SUBJECT: TRAFFIC METHODOLOGY APPROVAL LETTER
PROJECT NAME: ENCLAVE HOUSING CR 42 TRAFFIC IMPACT STUDY
PROJECT #2025010062 APPLICATION: #32409 PARCEL #47667-004-00

TECHNICAL MEMORANDUM

Date:	April 28, 2025	Project #: 31313
To:	Development Review Marion County Board of County Commissioners 412 SE 25 th Avenue Ocala, FL 34471	
From:	Emmanuel Masindoki, P.E. 225 E Robinson Street, Suite 355 Orlando, FL 32801	
CC:	Kok Wan Mah, P.E.	
Project:	Enclave Housing CR 42	
Subject:	Proposed Methodology for Enclave Housing CR 42

RE: Enclave Housing CR 42 Response to Comments

Figure 2. Project Trip Distribution

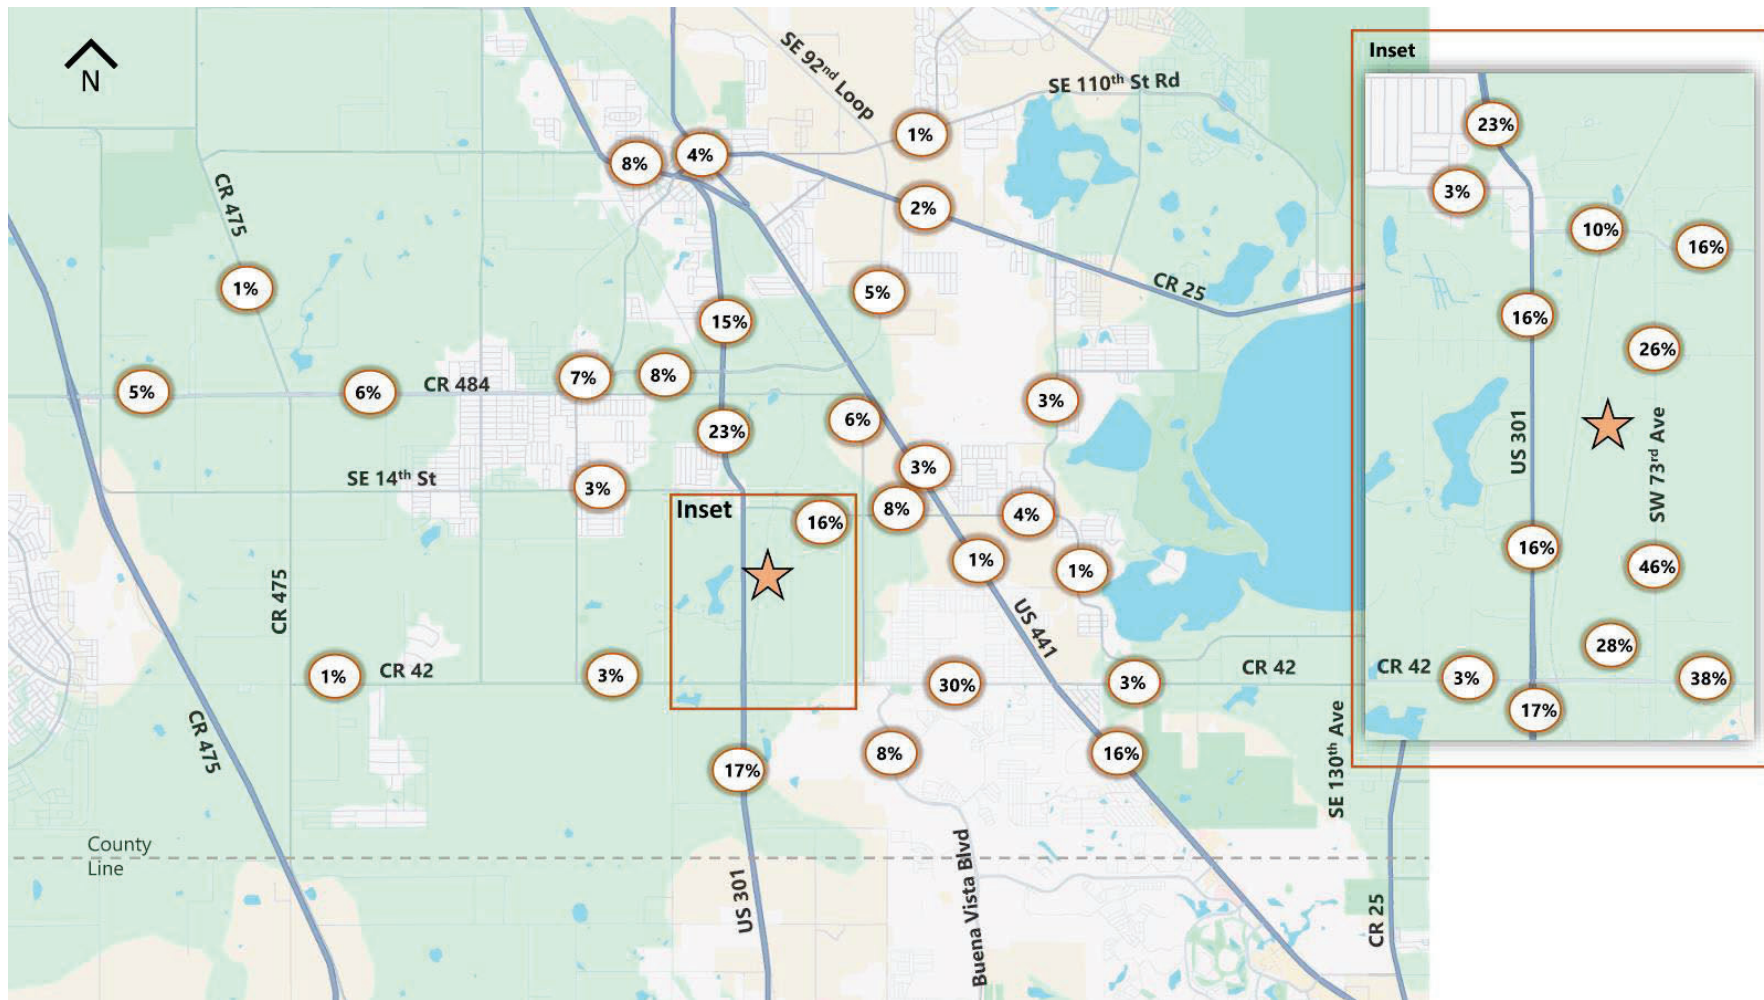
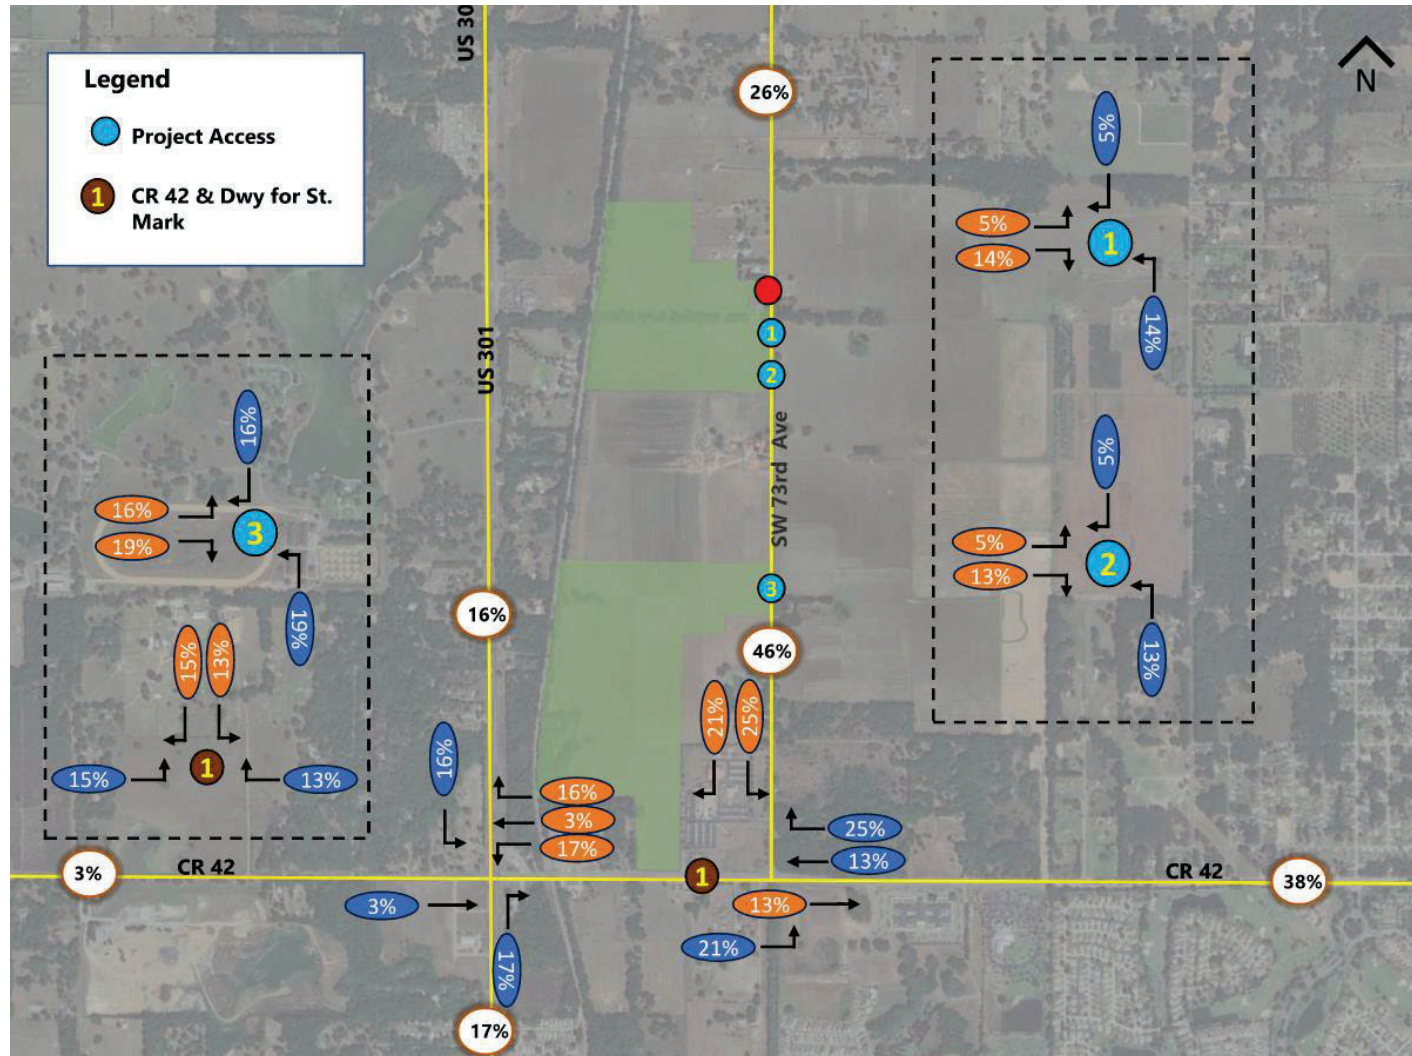
2. PDF pg. 4 & 5, Figures 2 & 3 - Figures 2 & 3 show different distributions to/from the south on SE 73rd Ave. Figure 2 shows 54% while Figure 3 shows 39%. Update the figures to show the same distributions on SE 73rd Ave. Ensure the distributions used in Table 2 also match the distributions shown on Figures 2 & 3.

Response: Agreed, and Figures 2 & 3 are updated accordingly.

4. PDF pg. 5, Figure 3 - The 39% to/from the south on SE 73rd Ave needs to be changed to 46% based on the distributions shown at the driveways on SE 73rd Ave

5. PDF pg. 5, Figure 3 - The 15% of eastbound through traffic on CR 42 at SE 73rd Ave needs to be changed to 13%.

Response: Figure 3 has been updated to show 46% to/from the south on SE 73rd Ave.

Response: Figure 3 has been updated to show 13% eastbound through traffic on CR 42 at SE 73rd Avenue.
